UNITED STATES PATENT AND TRADEMARK OFFICE

APPLICATION NO.	FILING DATE	FIRST NAMED INVENTOR	ATTORNEY DOCKET NO.	CONFIRMATION NO.
10/017,483	12/14/2001	David S. Wardrop	130109.431	5180

Office Action Summary

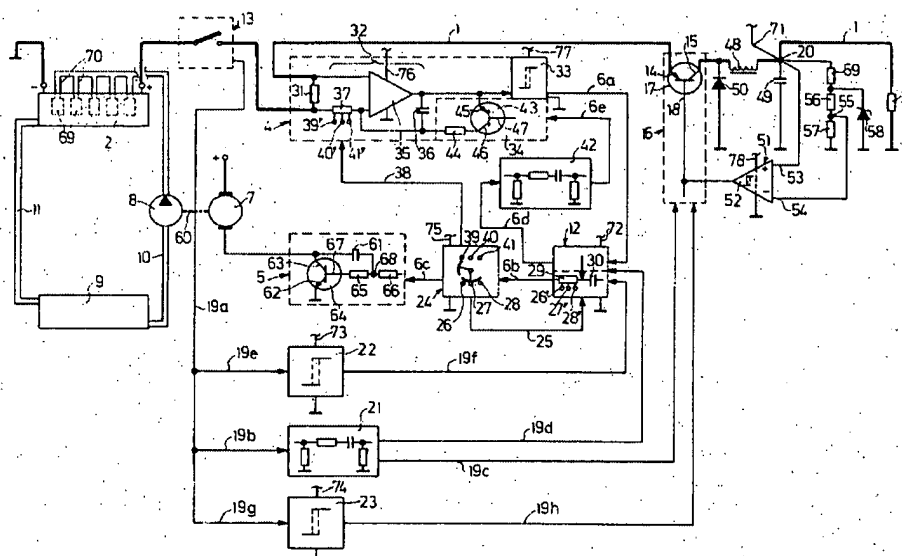
Figure 1 below gives a picture of a schematic diagram of a regulator system according to Keller et al's invention and shows the load is located upstream downstream from the fuel cell in an air flow communication therewith and proximate to the fuel cell.
